# Product Change Notification

**Change Notification #:** 920887-00

**Change Title:** Select Intel® Ethernet Network Adapters

**Change Detail:** Recycling symbol update for South Korean clamshells

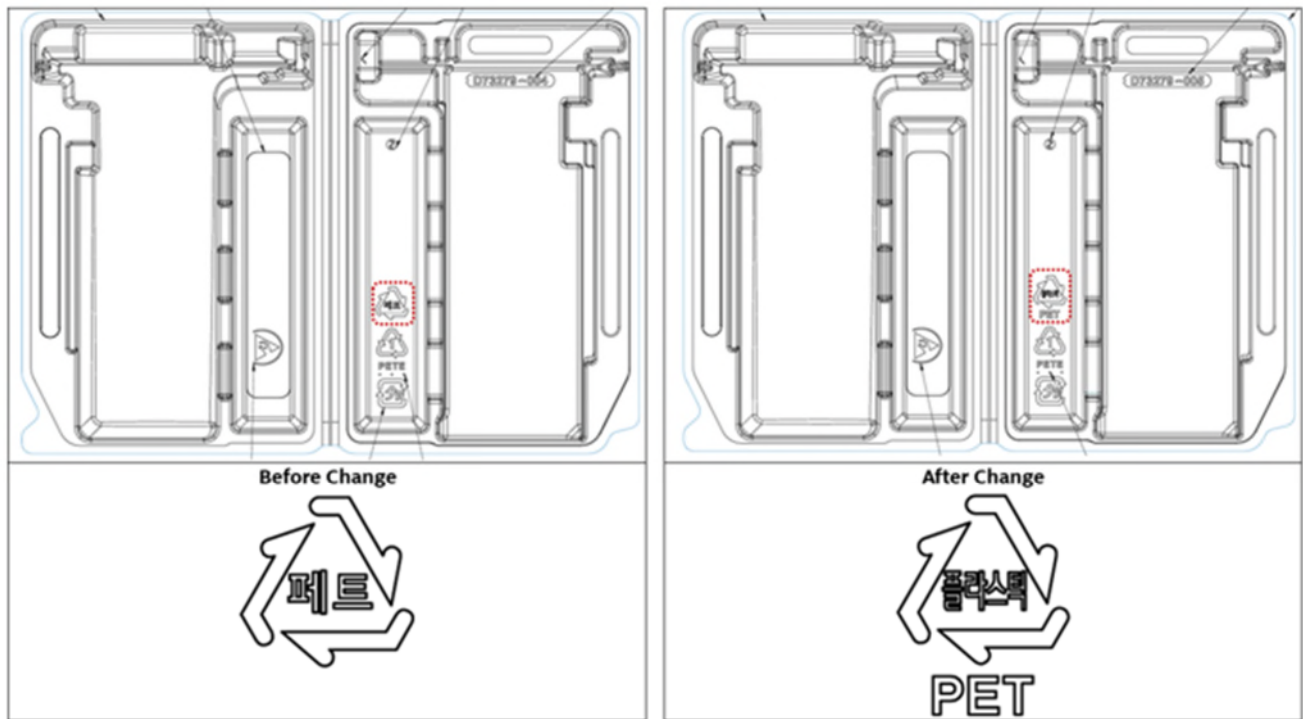
1. Permanent change to update the South Korean recycling symbol on clamshell. This update applies to all products listed in the Products Affected/Intel Ordering Codes table. The new clamshell is as shown below
